# Building Permit Application

Permit No.: **B19003324**

Description of Work: **1-STORY FRAME  
ADDITION ON FULL BSMT - 1,104  
SQ. FT ± AND COVERED  
STEEP & STEPS**

The percolation certification plan for **13440 Triadelphia Mill Road** has been reviewed with the following comments:

GRAHAM RESIDENCE  
EXIST'G 1ST FLOOR PLAN

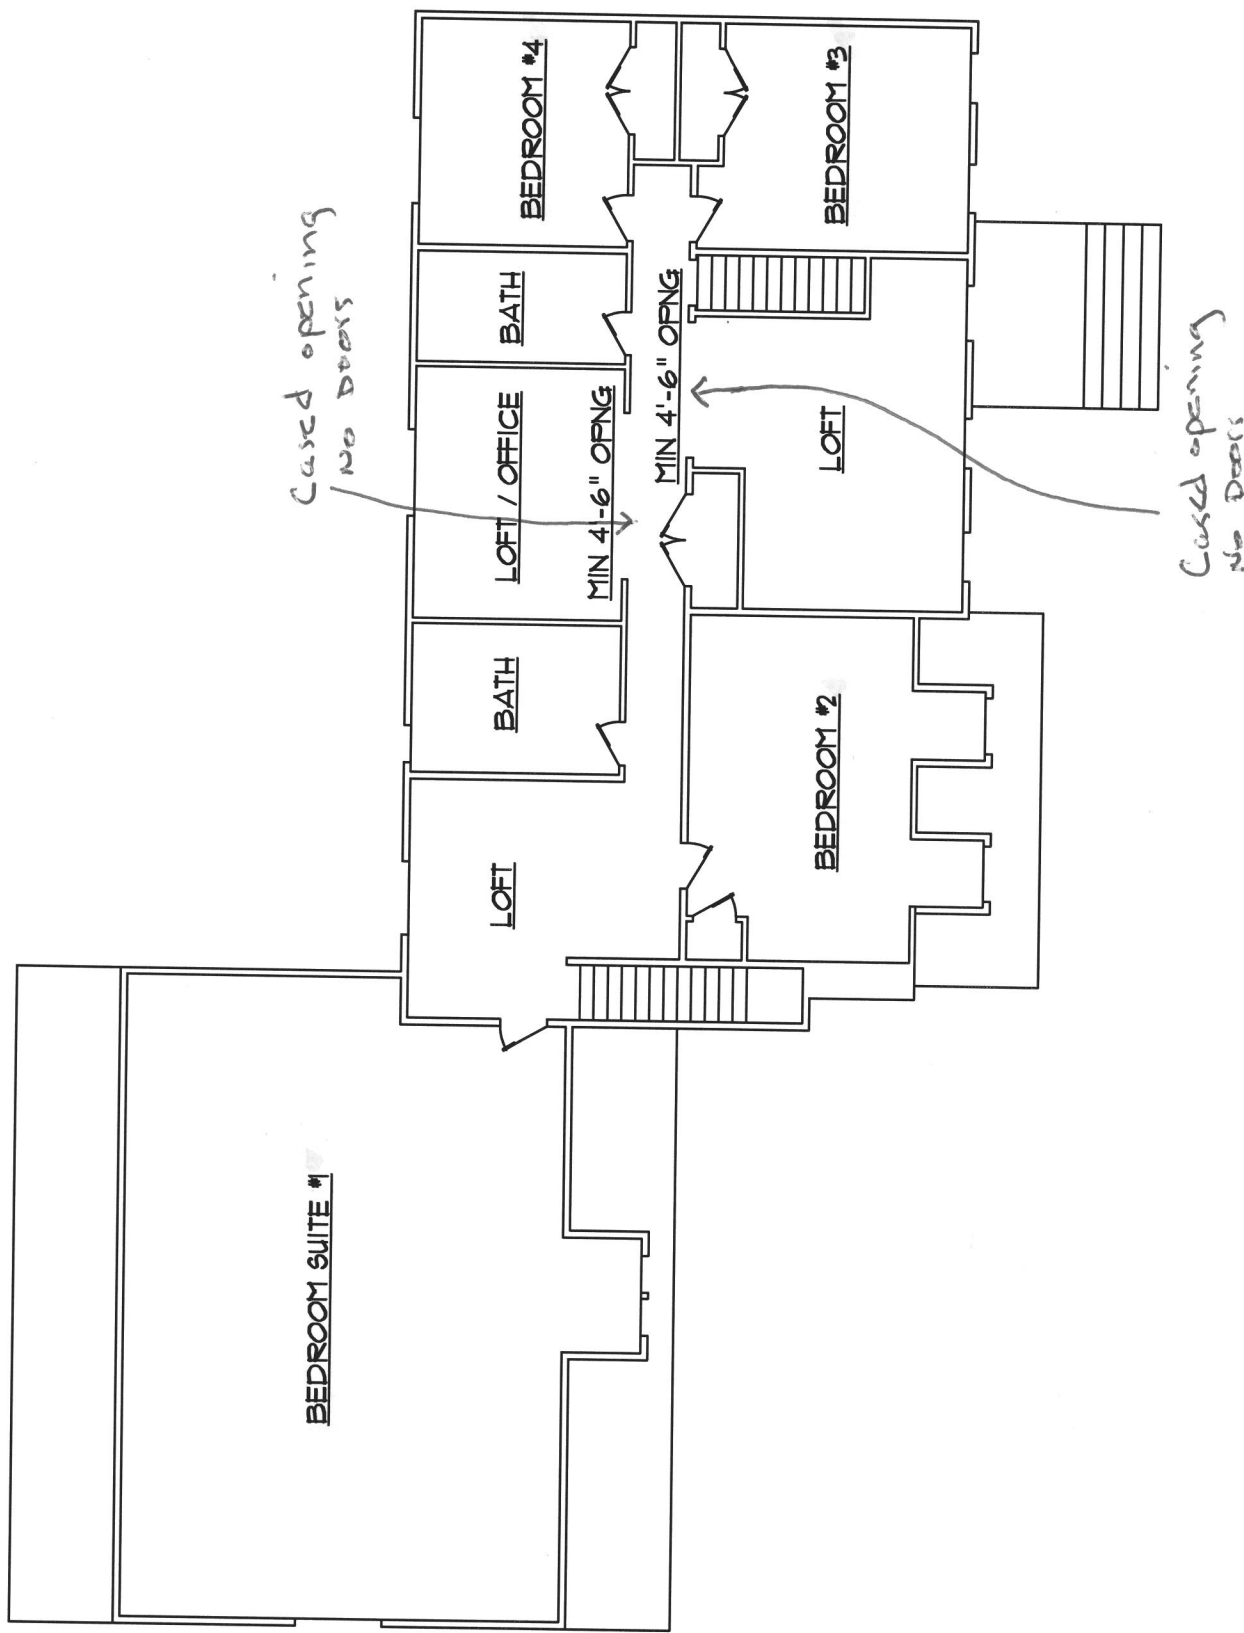
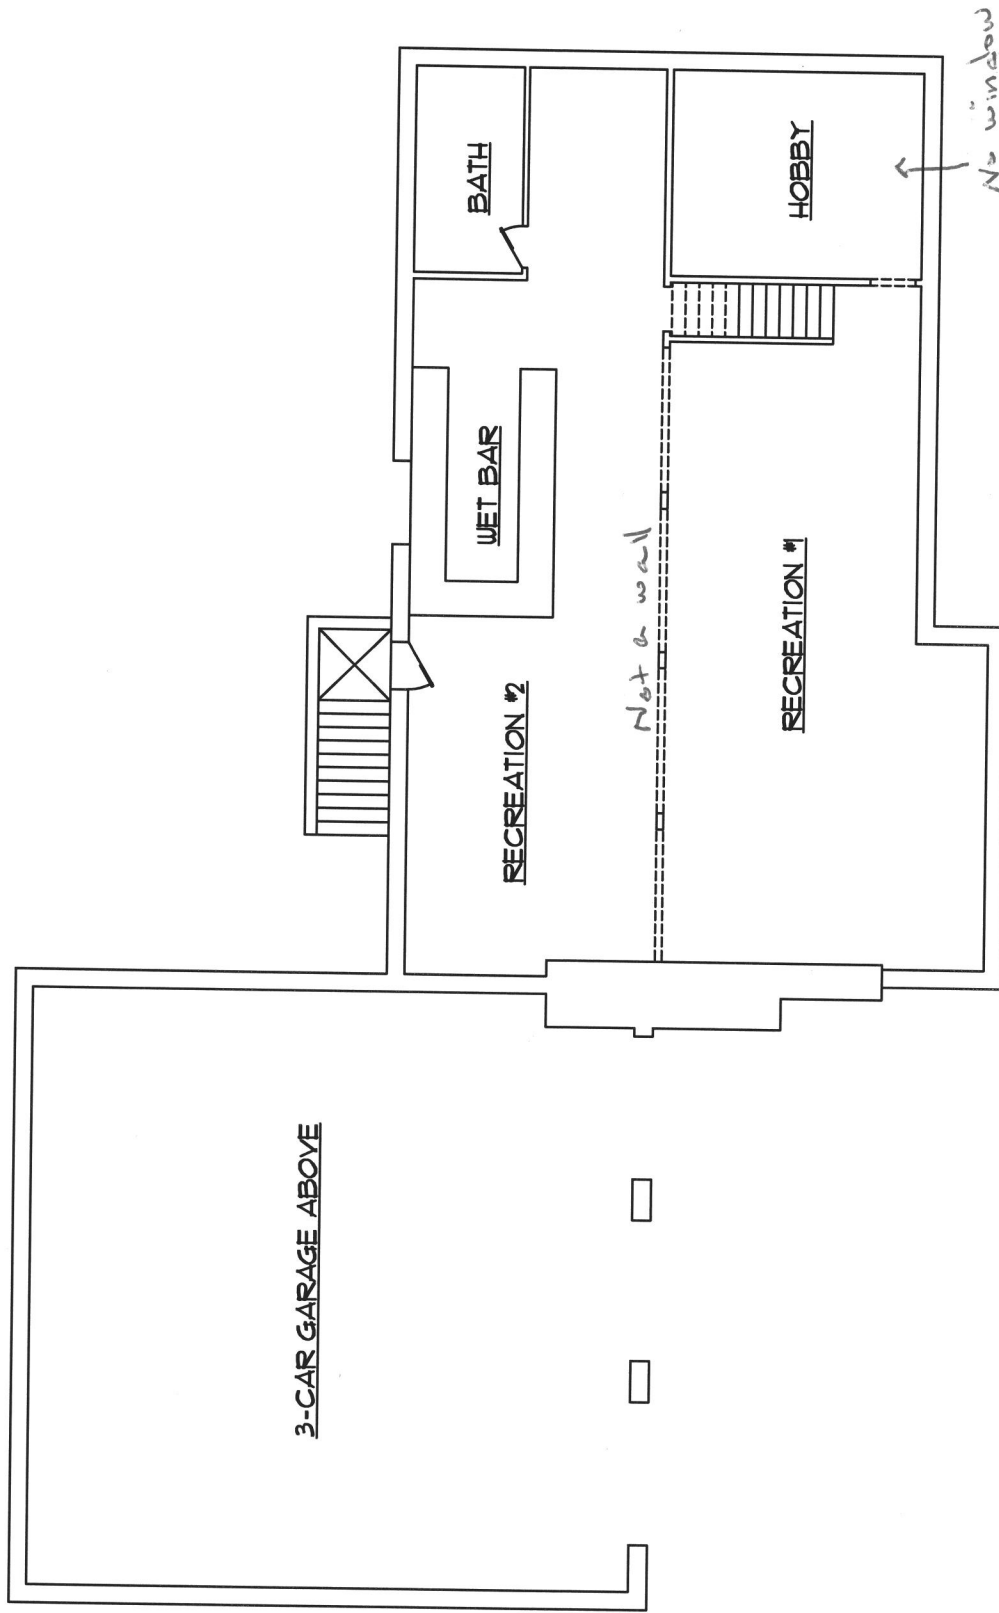
1. Can you send me the floor plans for the proposed addition?
2. Is the architectural site plan the same thing as the building permit site plan for this project? If so, it will need to be revised. I will explain why in my next email.
3. Does the basement hobby room have a window?
4. Are the rec rooms in the basement divided by a wall and door?
5. Does the first floor have a full bathroom? If so, revise plan to show it.
6. Does the loft/office on the 2<sup>nd</sup> floor have sliding doors for privacy?
7. Does the loft between room 2 and 3 have sliding doors and a wall between steps?

1. I'm just sending along the floor plans for addition - not all the elevations, sections, and details
2. The architectural site plan is the same as the site plan for the project - but they also made us convert it to an 11x17 size for the building plat - I'm now attaching that as well - the information is the same however
3. The existing basement hobby room did not have a window
4. There is no division in the rec rooms in the basement - no walls - it's wide open
5. There is no full bathroom on the first floor of the house
6. There are no sliding doors for privacy at the loft / office - it's a cased opening
7. There are no sliding doors for privacy at the loft between room 2 and 3 - it's a cased opening - there are walls between the loft and stairs going to first floor

DATE 8-14-71	BUILDER
FILE NAME GRAHAMENH	MODEL GRAHAM RESIDENCE
DRAWN BY BMA	DRAWING TITLE SITE PLAN
SHEET NO. C12	OPTION # & DESCRIPTION

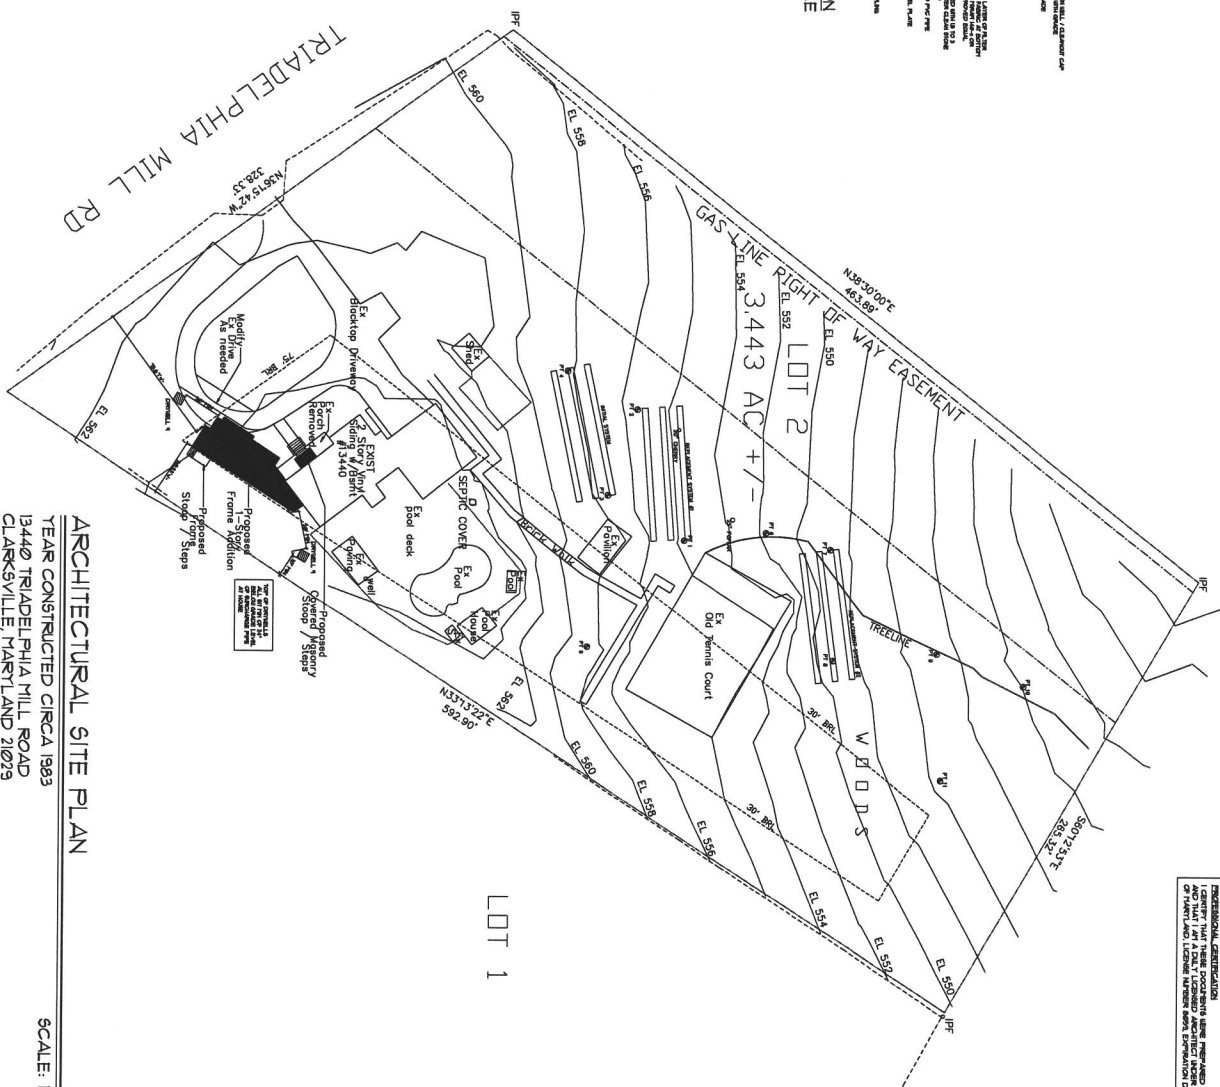
Was the property surveyed? The house location on the perc cert plan received 11/12/19 does not match the house location on the original building permit site plan. In addition, the shape of the proposed addition on the revised perc cert plan still isn't matching up with the BP site plan. Also, the addition on the perc cert plan doesn't show the steps/stoop along the BRL. Please see attachments.

Good morning. I looked over your perc cert plan this morning. The shape of the proposed addition on your plan submitted yesterday (11/7), does not match the proposed addition footprint on the building permit (BP) plan. Please see attached copy of the BP plan submitted with the building permit. In addition, the BP plan shows a drywell not meeting the setback of 100 feet from all well locations. All drywells must be located outside all well radiuses.

Please revise and submit showing correct proposed addition footprint and drywell(s) meeting required setback. The BP site plan will also need to be revised and submitted to the permit's office. As soon as I have at least 2 copies of the revised perc cert plan, I will submit for signature. Again, additional reviews by my supervisor and director will take at least 10 working days.
